UNITED STATES PATENT AND TRADEMARK OFFICE

APPLICATION NO.	FILING DATE	FIRST NAMED INVENTOR	ATTORNEY DOCKET NO.	CONFIRMATION NO.
10/771,479	02/04/2004	Les Jioia	G845	2849

Office Action Summary	Application No.	Applicant(s)	
	10/771,479	JIOIA, LES	
	Examiner	Art Unit	
	Hadi Shakeri	3723

DETAILED ACTION***Claim Objections***

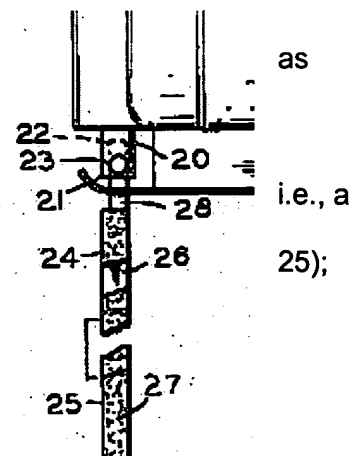
6. Claims 1, 2 and 14 are rejected under 35 U.S.C. 102(b) being anticipated by Barnes (3,914,906).

Barnes discloses all of the limitations of claims 1 and 14, sanding attachment comprising an elongated strip of metal (blade

an attachment end (28); a sanding end having a sanding strip (27); and at least one bend, Fig. 14.

Regarding claims 2 and 14, Baron meets the limitations, i.e., the bend having sufficient angle, and e.g., vertically lowering the tool, removing the attachment and storing all inherent.

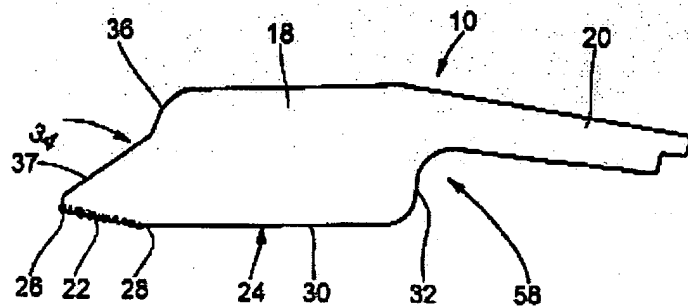
7. Claims 1-3 and 14 are rejected under 35 U.S.C. 102(b) as being anticipated by Romagnoli (6,149,510).

Romagnoli discloses all of the limitations of claims 1 and 14, i.e., a sanding attachment comprising an elongated strip of metal (10); an

attachment end (20); top and bottom surfaces (38, 24); a sanding end having a sanding strip (22); and at least one bend, (either notch 58, defining two bends or acute angle defined by 37).

Regarding claims 2-3, Romagnoli meets the limitations, i.e., the bend having sufficient angle; bends 58 and 37; sanding strip.

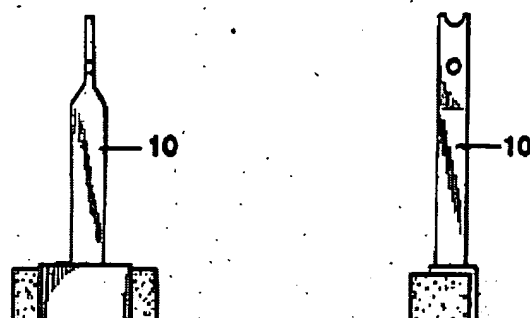
9. Claims 3-13 are rejected under 35 U.S.C. 103(a) as being unpatentable over Barnes in view of Harris (4,707,947).

Barnes meets all of the limitations of claim 3, i.e., two bends as shown in Fig. 14, except for disclosing an attachment end, which is perpendicular to the sanding end.

Harris teaches sanding attachment including embodiments wherein the attachment end is having a parallel plane with the sanding end or the rest of the blade, Fig. 2, like the arrangement disclosed by Barnes and attachment end perpendicular to the rest of the blade, Fig. 1. It would have been obvious to one of ordinary skill in the art, at the time the invention was

made, to modify the invention of Barnes with attachment end as taught by Harries to adapt the sanding attachment for a particular power tool requiring such arrangement.
